HEBER CITY CORPORATION
75 North Main Street
Heber City, UT 84032
Planning Commission Meeting

August 22, 2023

New London South Pad – Site Plan

1 TRASH ENCLOSURE - FRONT ELEVATION

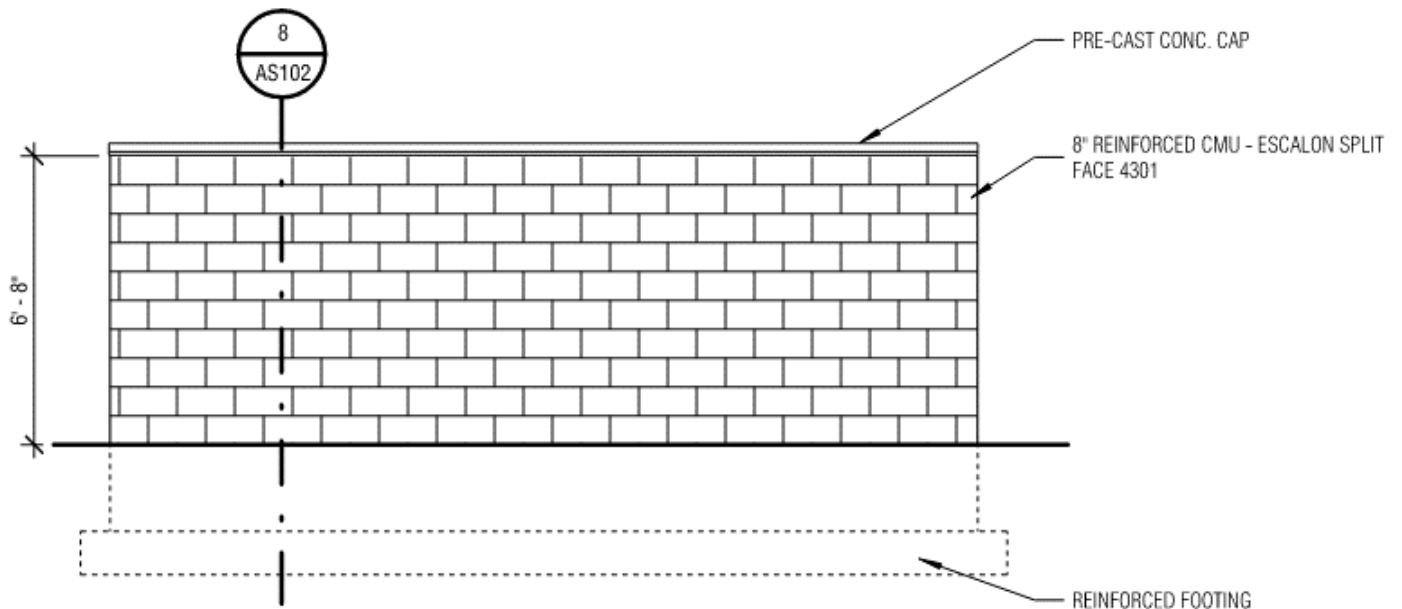
All trash areas shall be screened on all four sides by 6' high walls and be hidden from public view. **Is a trash enclosure detail provided?** (Need to verify the enclosure meets the 6' high wall requirement)

AWA RESPONSE, "A FULL DUMPSTER ELEVATION WILL BE PROVIDED AS PART OF THE BUILDING PLANS. DUMPSTER TO MATCH BUILDING ARCHITECTURE AND IS PROVIDED BY ARCHITECT PLANS."
